Reviewed by  
dsdgrimm  
03/28/2019 12:27 PM

# PRELIMINARY AND FINAL DRAINAGE PLAN AND REPORT

## POENITSCH SUBDIVISION

### EL PASO COUNTY

# DRAINAGE PLAN

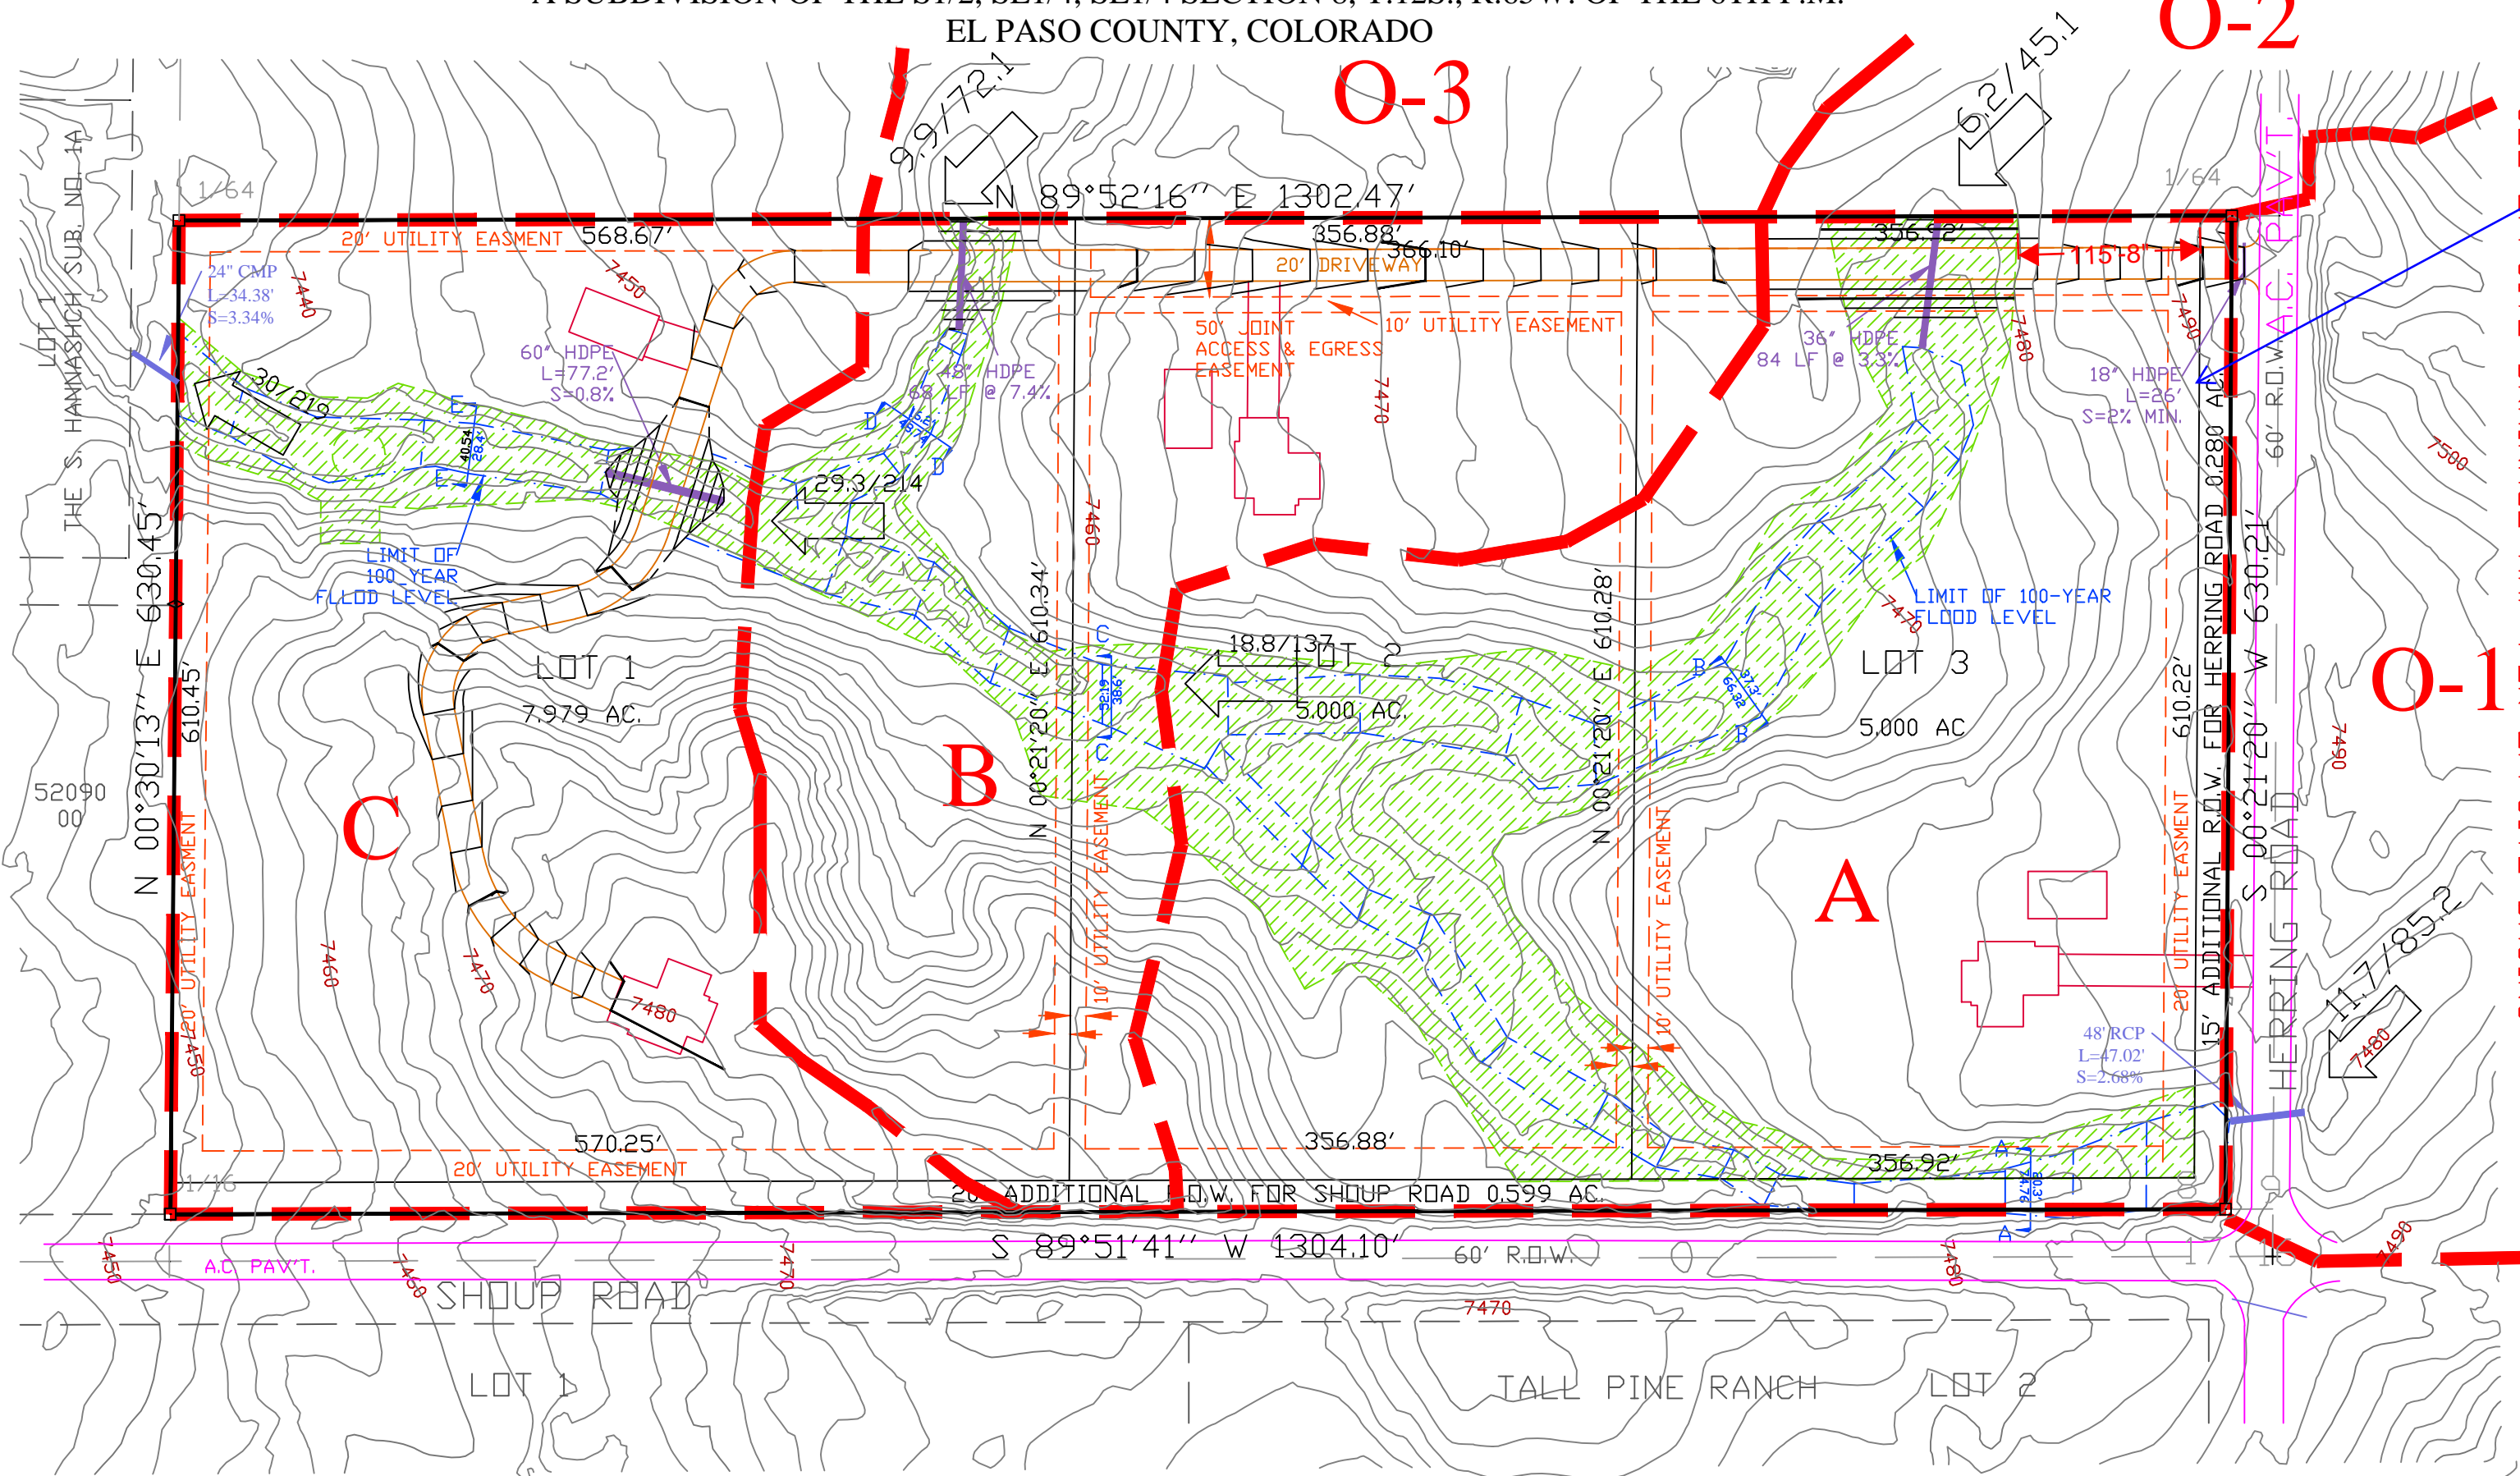
Any changes to the plat must be reflected here as well.

HPDE Pipe is not permitted for driveway culverts, per driveway access permit requirements. Please revise to show either CMP or reinforced concrete. Update accordingly in Cost Estimate.
